**Report of the Transportation Advisory Committee
to the
Arlington Board of Selectmen**

11 July, 2005

Dallin School

Figure 1 Dallin School Safety Recommendations

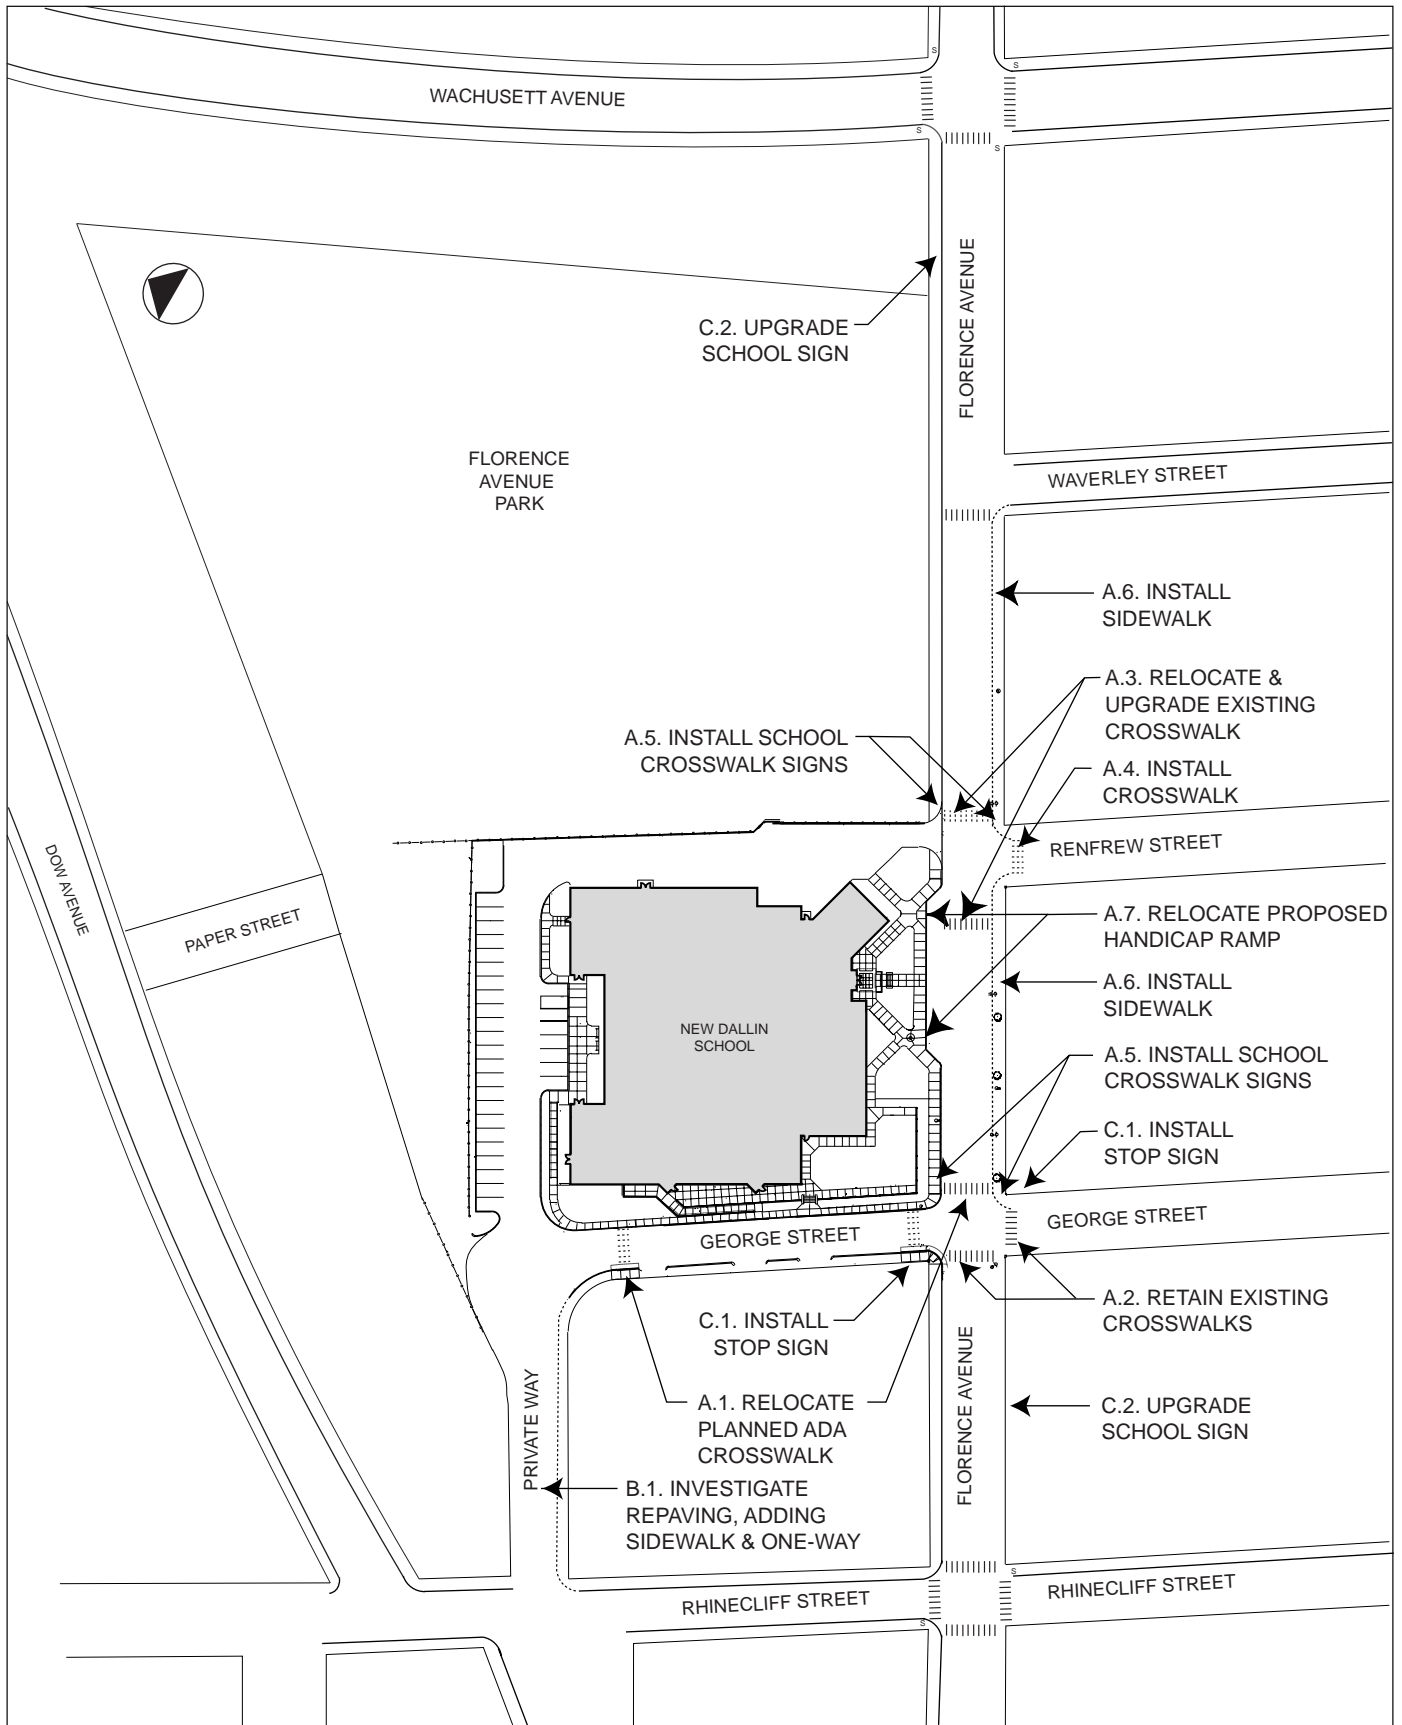
Figure 1 illustrates the recommended items in the immediate neighborhood of the school.

- A.1. Relocate the planned ADA compliant crosswalk from the north end of George Street to Florence Avenue at George Street adjacent to the Dallin School. (This crosswalk is planned and budgeted as part of the Dallin rebuild project.)

- A.2. Retain the existing crosswalks on Florence Avenue at the west side of George Street, and on George Street at the south side of Florence Avenue.
- A.3. Relocate and upgrade the crosswalk on Florence Avenue at Renfrew Street from the west side to the east side of the intersection.

- A.4. Install a crosswalk on Renfrew Street at Florence Avenue.
- A.5. Install school crosswalk signs in each direction on the Florence Avenue crosswalks at the east side of George Street and at Renfrew Street.

- A.6. Install sidewalk along the south side of Florence Avenue (the side opposite the school) between George Street and Waverley Street to allow the installation of ADA compliant crosswalks.

- A.7. Work with the Dallin School project architect to relocate the planned handicap ramp in the school drop-off zone on Florence Avenue from the east end to the west end.

- B.1. Investigate improvements to the Private Way section of George Street, including repaving, adding a sidewalk and making this section one-way leading away from the Dallin School.

- C.1. Install stop signs on George Street at both approaches to Florence Avenue.
- C.2. Upgrade the school signs at both approaches on Florence Avenue.
- C.3. Investigate creating a School Zone with speed limits for the Dallin School.
- C.4. Investigate installing traffic calming device(s) (e.g. raised pavement) along Florence Avenue.

Figure 3 Possible School Zone Signs

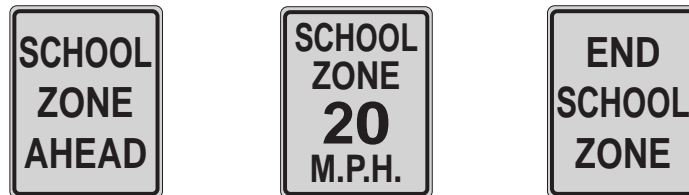
The creation of a School Zone for the Dallin School could also be considered by the Town. Arlington currently has two School Zones, at the Brackett and the Peirce Schools. A School Zone could either be outfitted with flashing signs, as with the Brackett and Peirce, or with standard signs similar to those shown below. These signs would replace the signs in recommendation C.2. above and would likely encompass a slightly different section of Florence Avenue.

Recommendation C.3. Investigate creating a School Zone with speed limits for the Dallin School.
